# TT413: 2009 - 2020 TOURING REAR FORK RUSTY WATER LEAKAGE

2020-06-09

APPLIES TO	SYMPTOMS
2009 - 2020 Touring, Touring CVO, Touring Police Models	Fluid or Oil Leaks
	Cosmetic Information

Figure 2. Debris Deflector

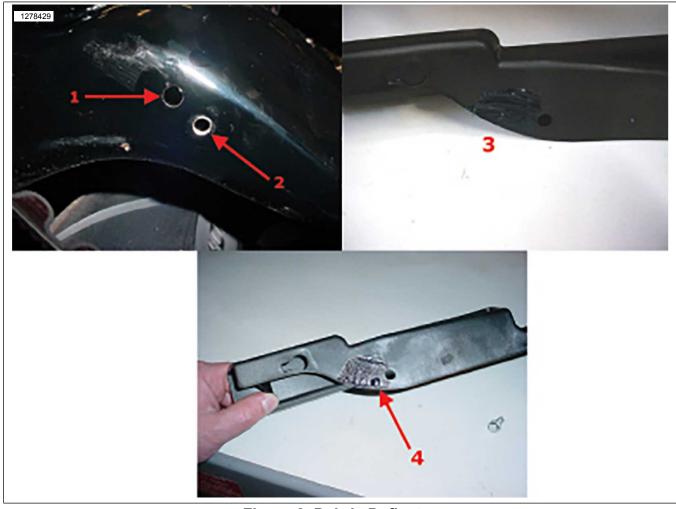
The potential water entry points are a forward facing drain hole (used in production) in the pivot shaft area, the two upper holes for the brake line retention clips, and the holes underneath the lower belt guard. On low mileage vehicles this may be residual after-wash from manufacturing's pre-paint procedure that did not boil out during the paint bake process, or it may be from external sources (puddles, washing, etc.) after the motorcycle was put into service. Depending on the amount of debris remaining inside the rear fork from the manufacturing process, and the fact the belt's debris deflector runs across the lower drain hole, it is possible for the water to build up and become contaminated. Air flow from riding can cause the stagnant water to slowly work its way out of the rear fork and onto the rear of the vehicle.

Harley-Davidson recommends opening up a clear escape path for the water to exit by:

- Removing the debris deflector.
- 2. Marking the location of the rear fork drain hole.
  - a Use some grease to find the drain hole (just forward of the center mounting screw).
- 3. Drilling a 6.4 mm (0.25 in) hole in plastic debris deflector (not the rear fork), directly in line with rear fork drain hole.
- 4. Clean vehicle (if necessary).
- 5. Reinstall the modified debris deflector
